# City of Corpus Christi

### Planning Commission

Wednesday, June 11, 2025

**TECHNICAL REVIEW PLAT REQUIREMENTS  
REGULAR PLANNING COMMISSION MEETING**

# PLAT OF: C G CLASSCOCK BAYFRONT ADDITION LOT 1A AND LOT 1B

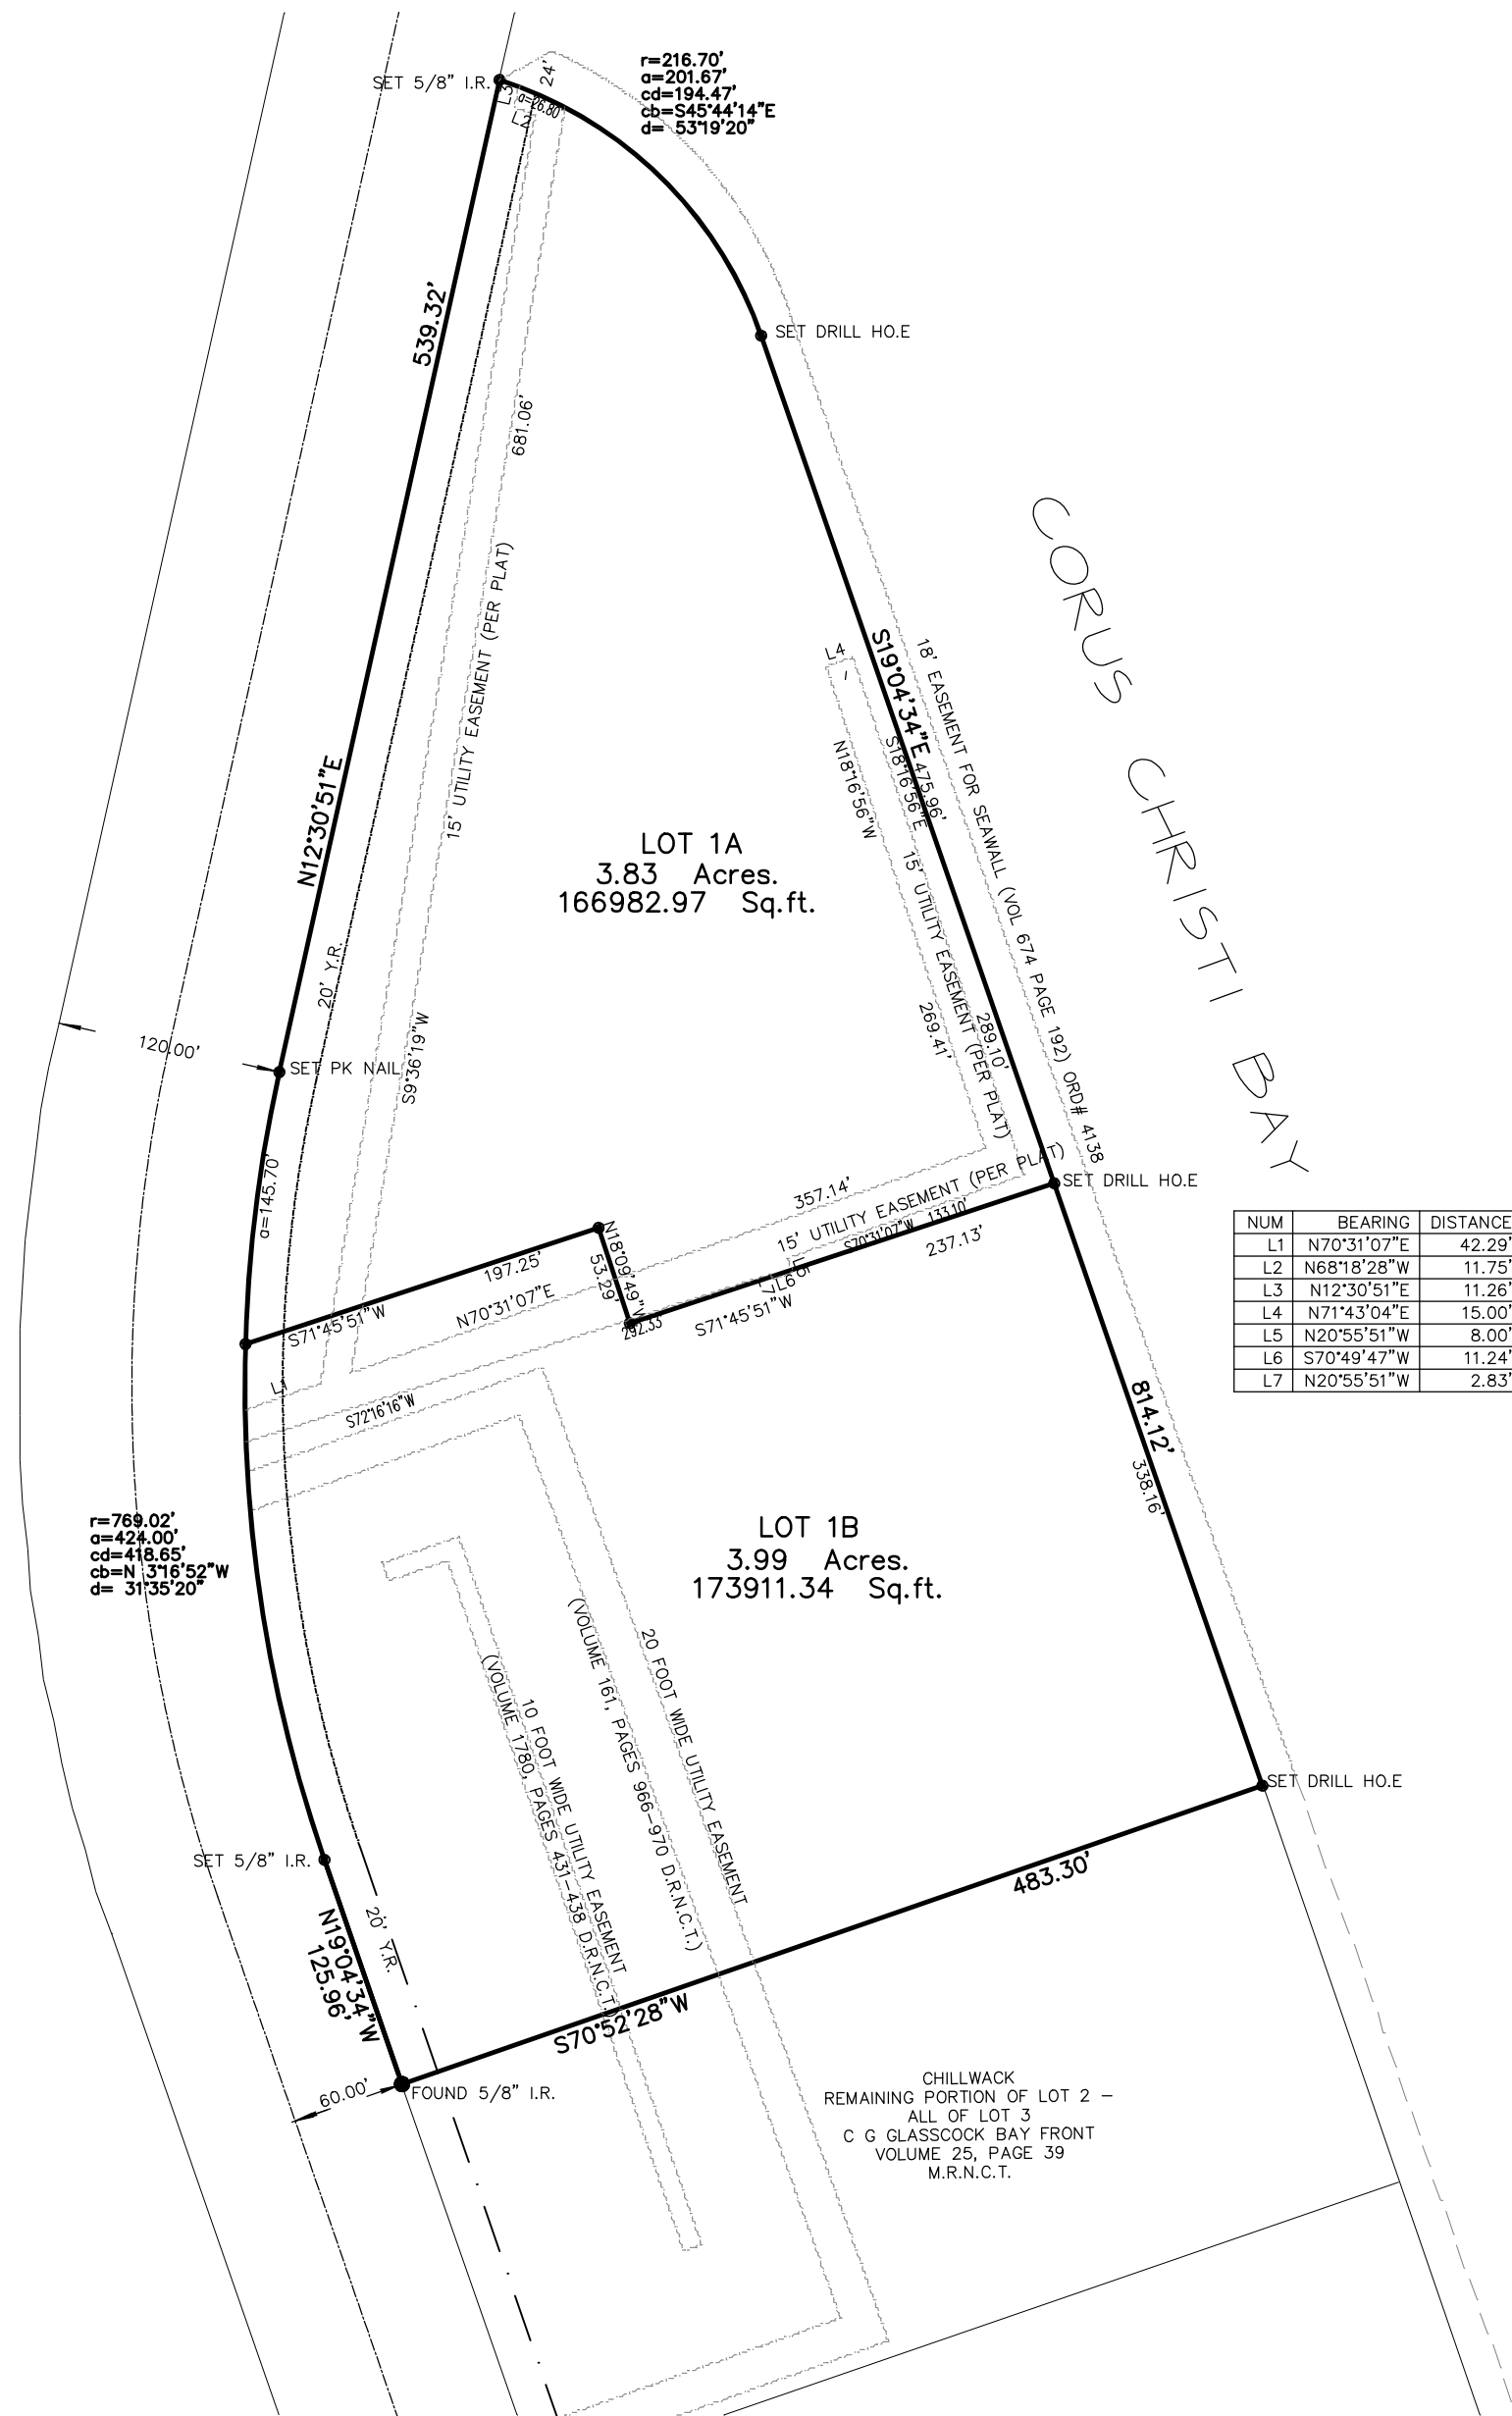
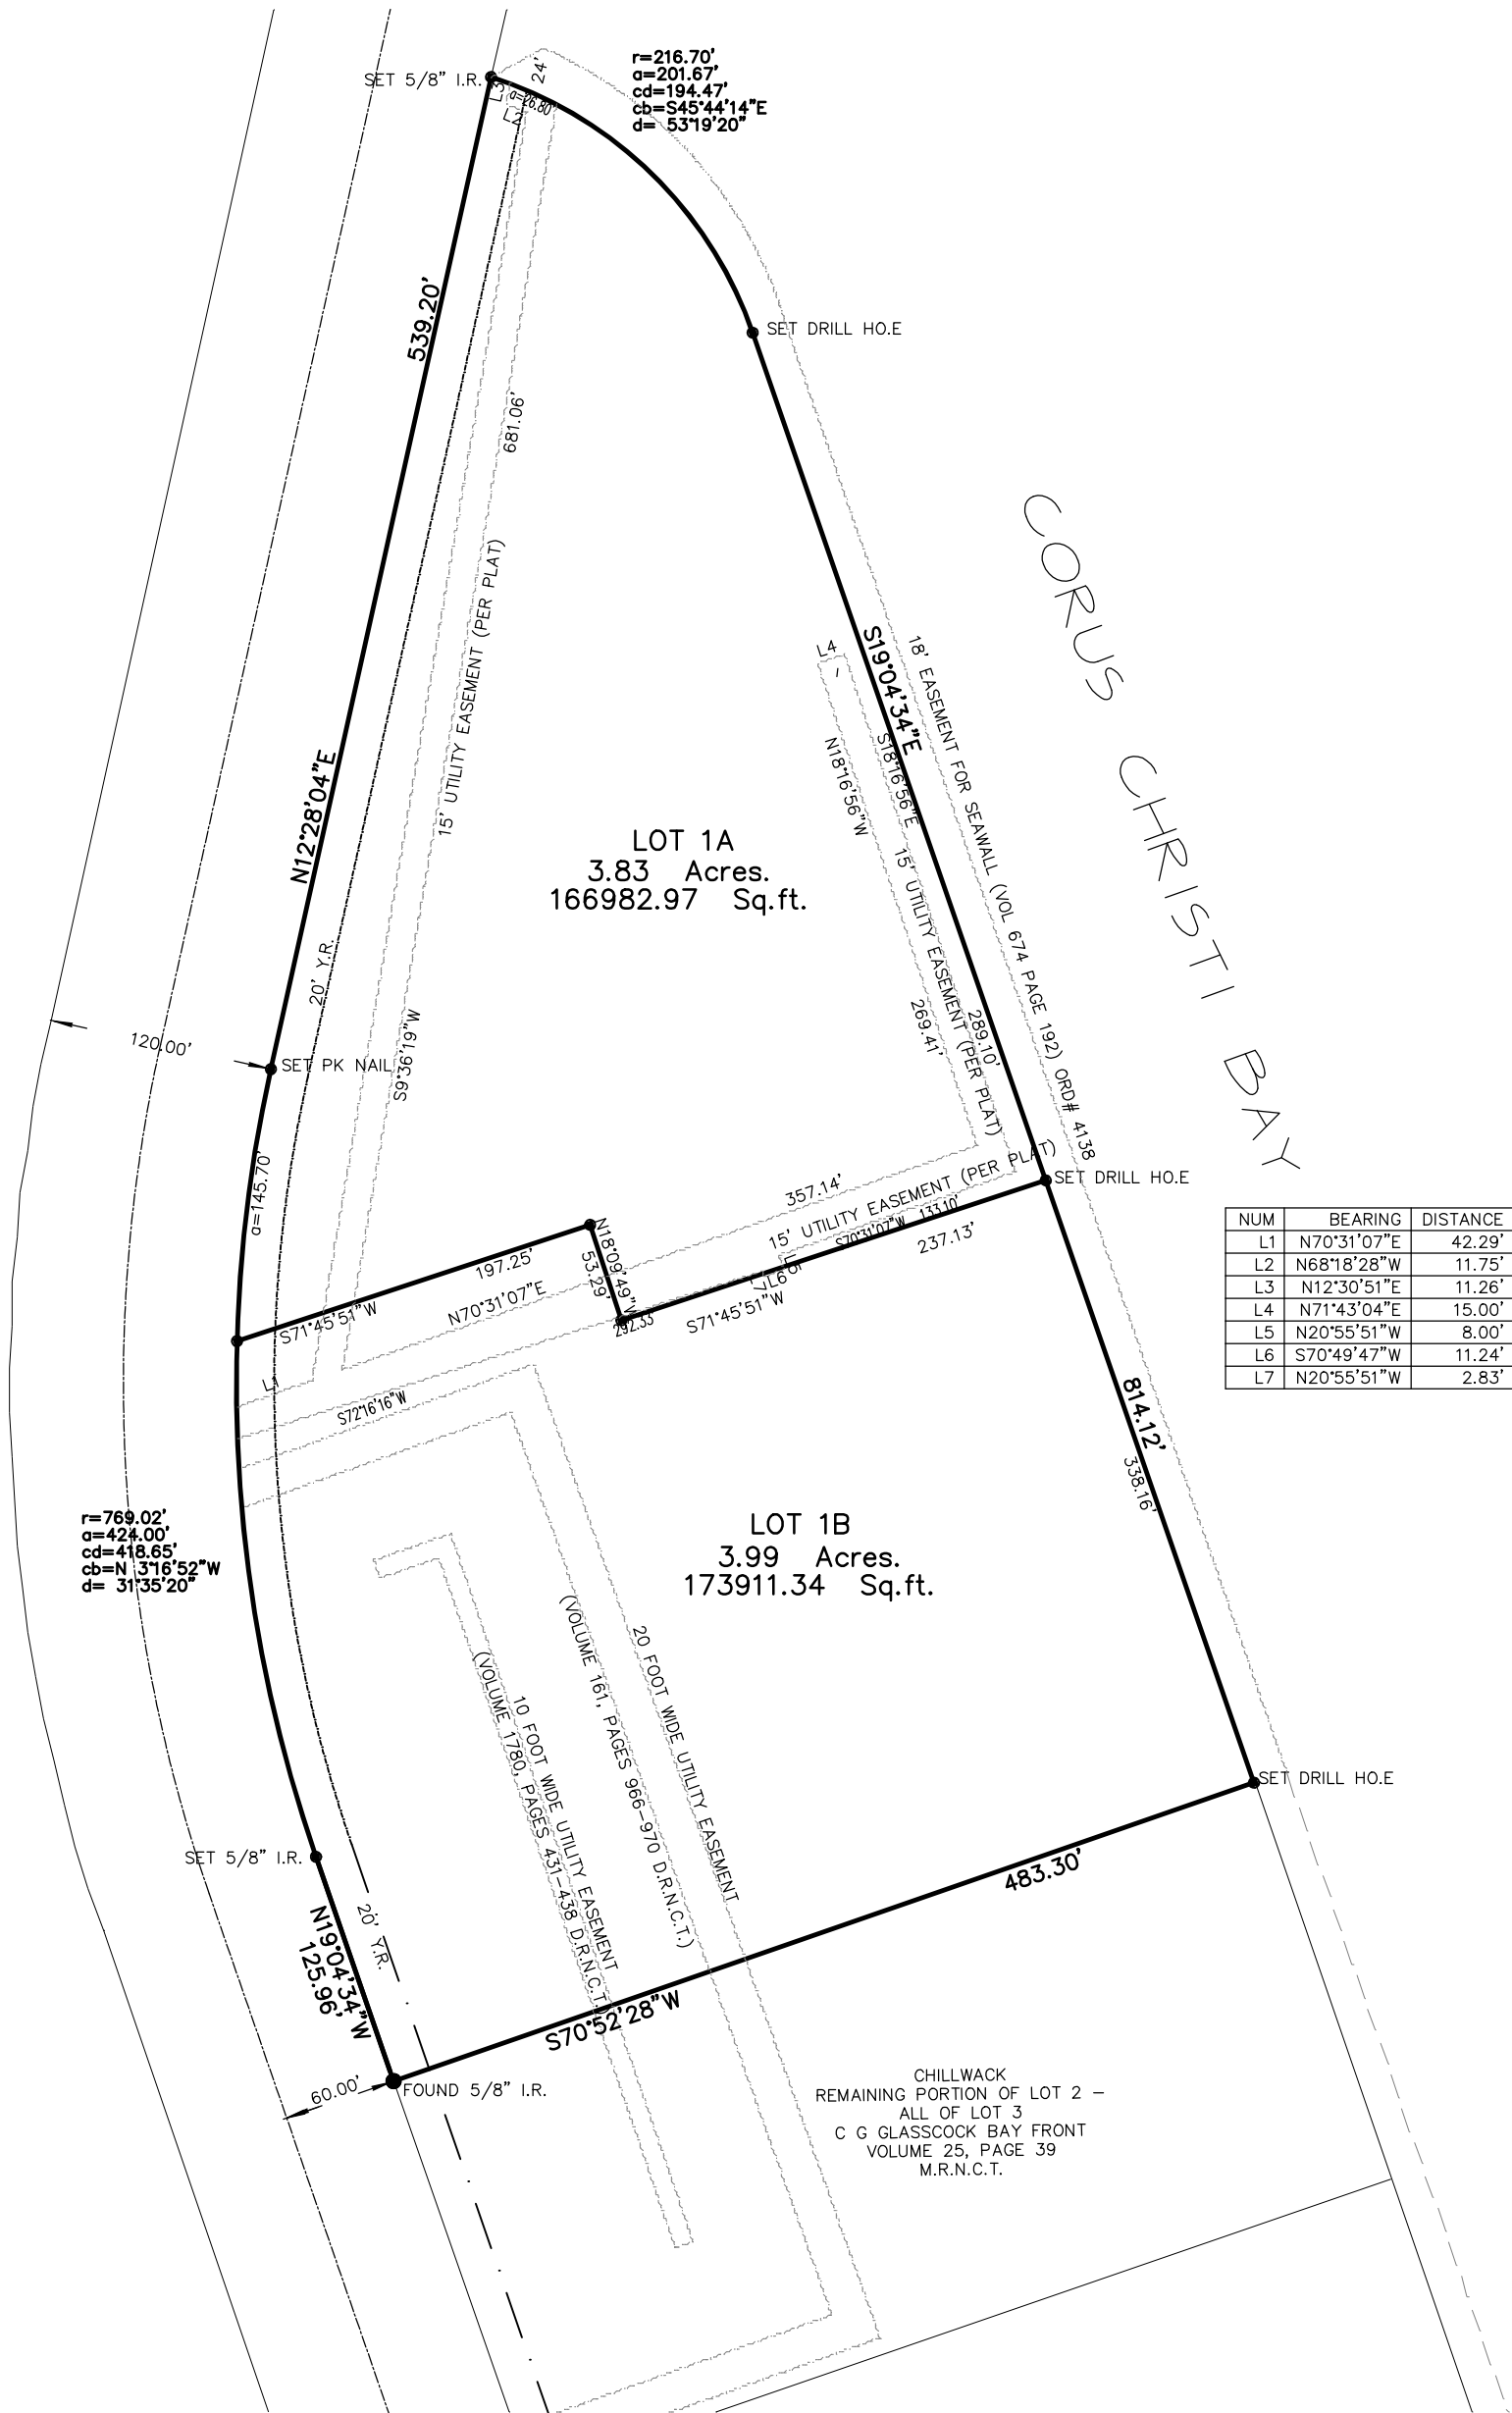
<b>Comment ID</b>	<b>Page Reference</b>	<b>Annotation Type</b>	<b>Author : Department</b>	<b>Status</b>	<b>Review Comments</b>	<b>Applicant Response Comments</b>
18	P001	Note	Mark Zans : LD	Open	Updated comments: 6/4/2025: The cross access easements need to be aligned with the driveway from the entrance of lot 1 to the driveway to Lot 2 see below:  7.1 Access and Circulation 7.1.8. Shared and Cross Access Driveways A. In order to promote traffic flow and to achieve the driveway standards contained in this Section, a

Comment ID	Page Reference	Annotation Type	Author : Department	Status	Review Comments	Applicant Response Comments
					<p>shared or cross access easement or a note stating shared or cross access shall be allowed across lot lines shall be encouraged as part of a driveway permit, subdivision plat, rezoning or development agreement.</p> <p>B. A shared access driveway or access between properties shall be created when a joint contractual agreement, easement shown on the subdivision plat, or easement filed for record by separate instrument is entered into by the respective property owners of the adjacent properties.</p> <p>C. Cross access easements shall be situated parallel to the street right of way line and laid out in such a manner to enable future connection to adjacent properties.</p> <p>D. No permanent structure, obstructions, or parking that would interfere with the cross access shall be permitted within the easement. Improvements such as medians and islands are allowed within the easement provided that cross access and circulation between properties is not impaired.</p> <p>E. Cross access easements shall be waived in those cases where topography or site conditions would render such easement of no benefit to adjoining properties.</p> <p>F. The Assistant City Manager of Development Services may grant a reduction in driveway spacing requirements, landscaping requirements, and the required number of parking spaces, on a case by case basis, in order to achieve cross access.</p> <p>If you have any further questions, please feel free to contact ROW / Traffic at your convenience.</p>
